# Memorandum

**RE:** **P.Z. 20-2019 Briarcliffe Villas (14001 Olive Blvd)**: A request for a change in zoning from R-3 Residence District to PUD Planned Unit Development for a maximum of 117 residential units (16R340151). (Ward 1)

Re: P.Z. 19-2019 & P.Z. 20-2019 Briarcliffe Villas, Response Letter (Stock Project No. 219-6568)

SHEET NO. **C1.0**

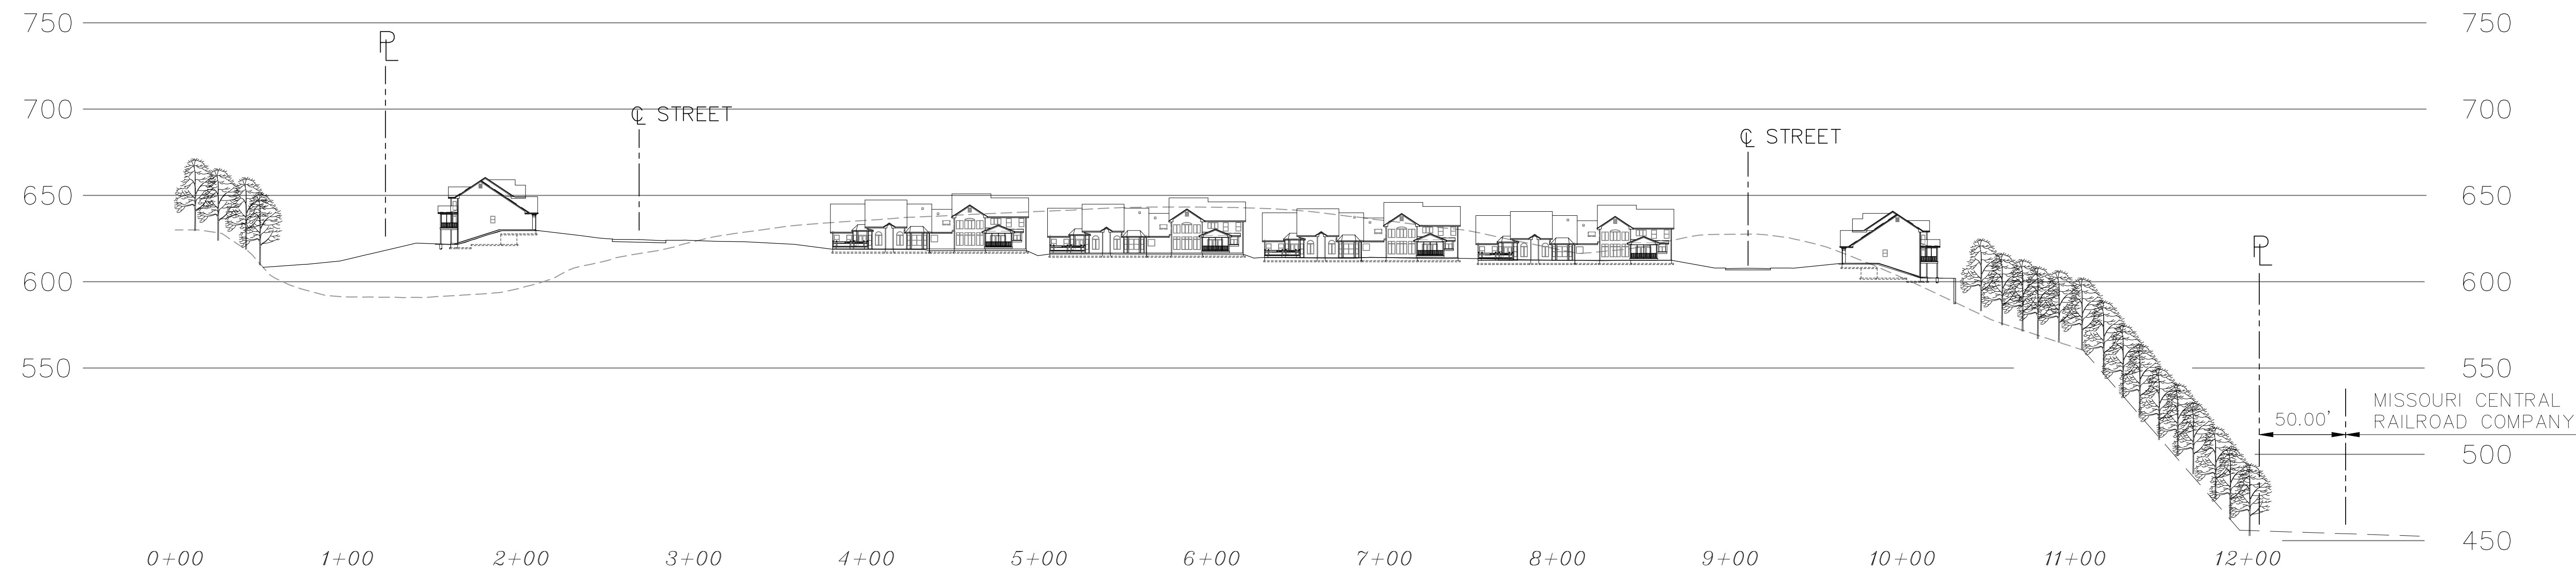
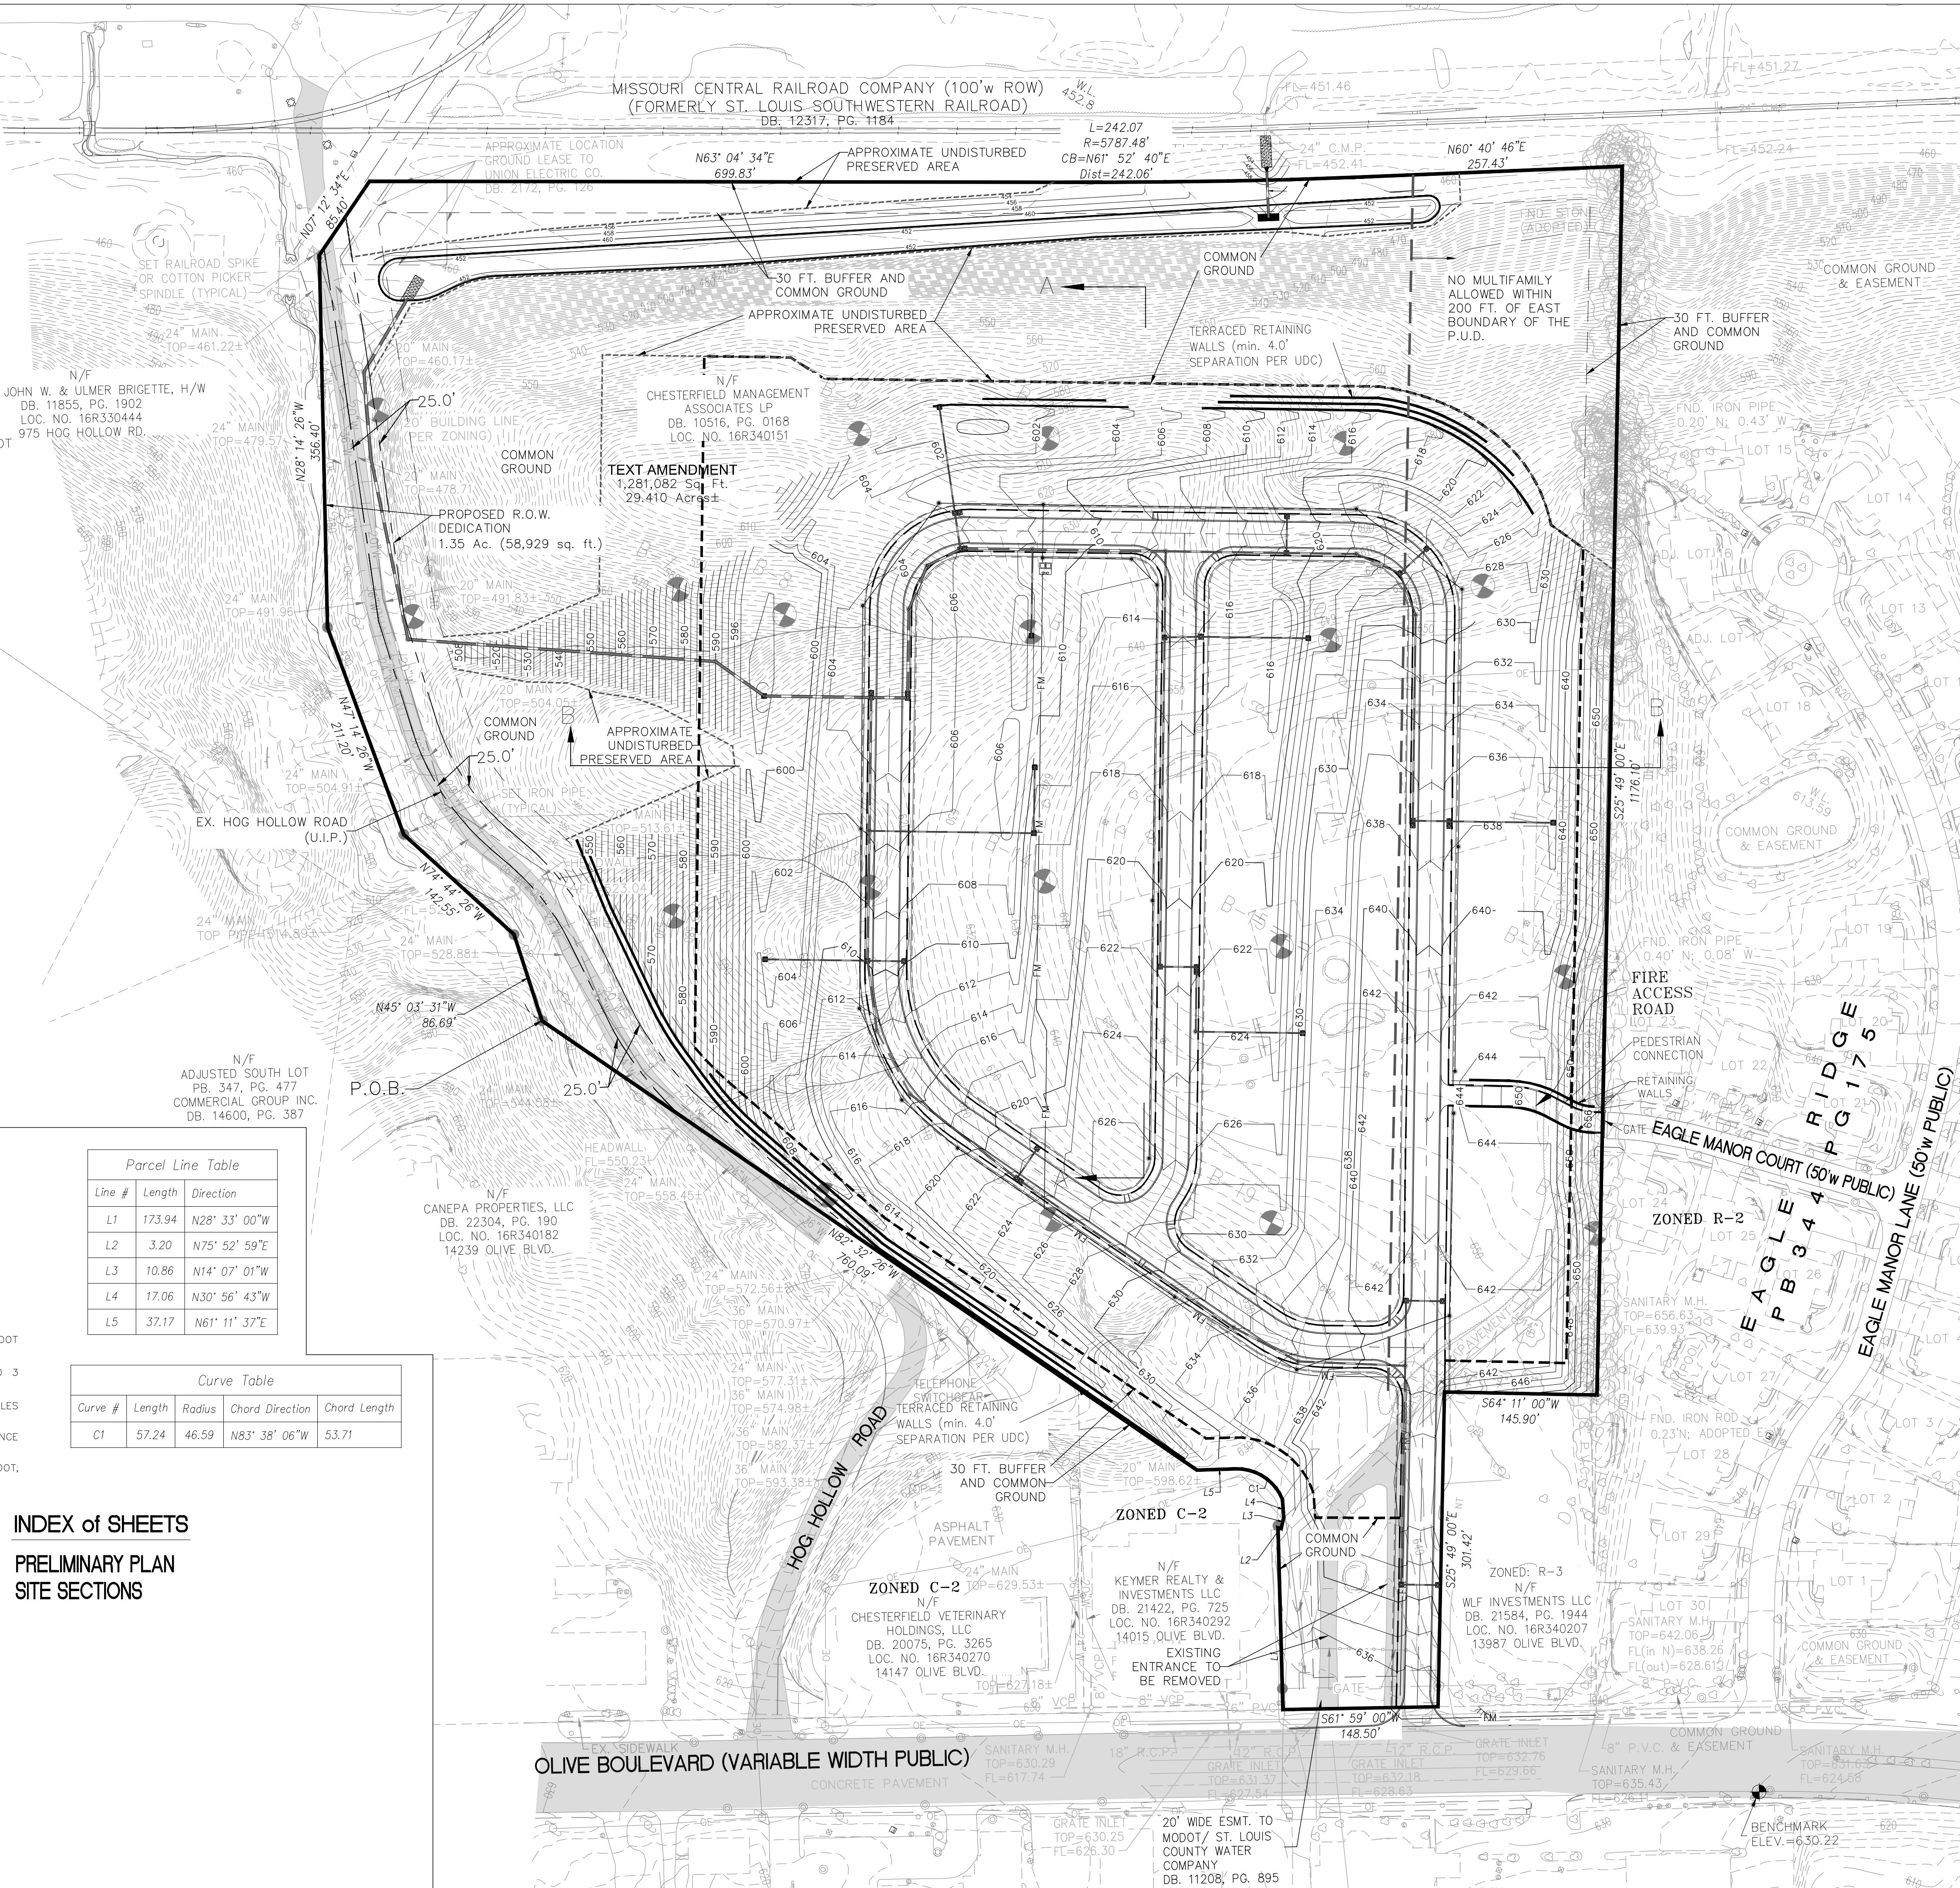
1. Per Unified Development Code § 31-04-02N, at staff's direction, submit a request for modification for the perimeter buffer on the southeast portion of the lot.

2. Show the limits of the depicted Common Ground areas, specifically regarding the common ground by the entrance off of Olive Boulevard.

3. Revise the note by the 200' setback line to reflect multifamily rather than condominiums.

**Response:** We respectfully request a waiver for a thirty (30) foot landscape buffer along the west property line of property at 13987 Olive Blvd. In order for this property to have vehicular access to a “Public Street”, P.Z. 20-2019 proposes to abut the Public Street Right-of-Way adjacent to the west property line of 13987 Olive Blvd.

**Response:** Information added to the Preliminary Plan.

**Response:** Information added to the Preliminary Plan.
